REMARKS

Docket 02230028BB
Serial No.: 10/803,144

ANNOTATED MARKED-UP
 DRAWINGS

FIG. 63

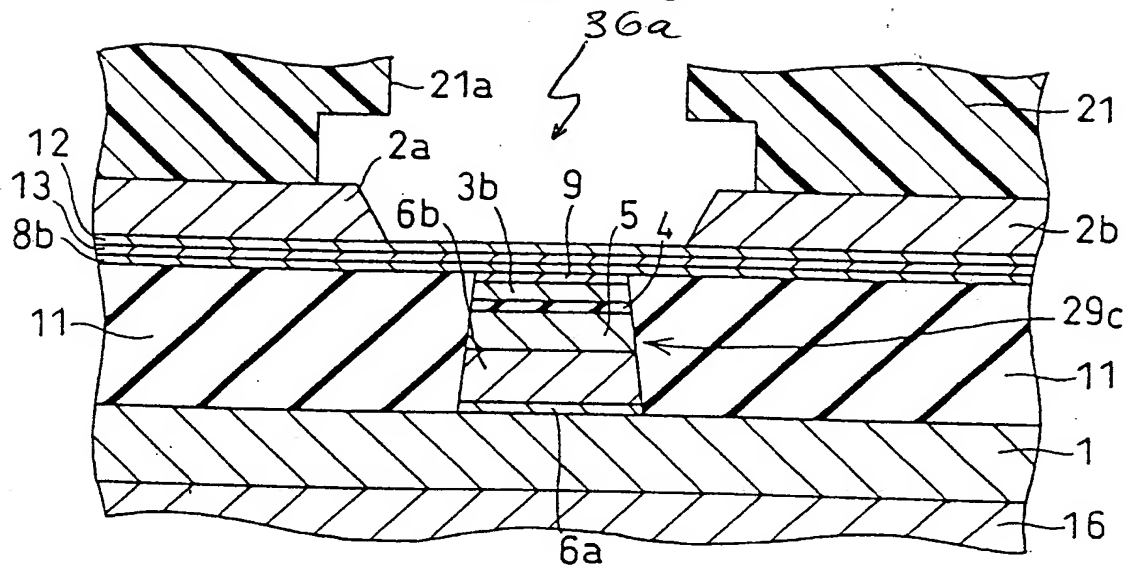
In addition, Figure 64 has been also amended in order to show a structure designated with numeral 66a which is a magneto-resistant effect head of the eight embodiment as a whole. Also, it has been noted that the reference 36a is not shown in Figure 63, as described in the specification on page 60, line 17. So, the reference 36a, designating a magneto-resistance effect element, was added to Figure 63. No new matter has been introduced by this amendment. The Examiner is respectfully requested to replace the formal figures 63, 64, filed on March 17, 2004, with currently provided "Replacement Sheets" of corrected Figures 63 and 64.

Responding to the Examiner's objection, Figure 64 has been corrected by this amendment in order to add the reference numeral 66a, showing a whole structure of a magneto-resistance effect head of the eighth embodiment, described on pages 59 to 65 of the specification. Additionally, the reference numeral 36a, designating a magneto-resistance effect element, has been added to Figure 63 in accordance with the specification description on page 60, line 17. This paper is accompanied with a "Replacement Sheet", showing corrected Figures 63 and 64 and marked up in red "Sheet Showing Changes". The Examiner is respectfully requested to replace a formal drawing of Figures 63, 64, filed on March 17, 2004, with the currently provided "Replacement Sheet".
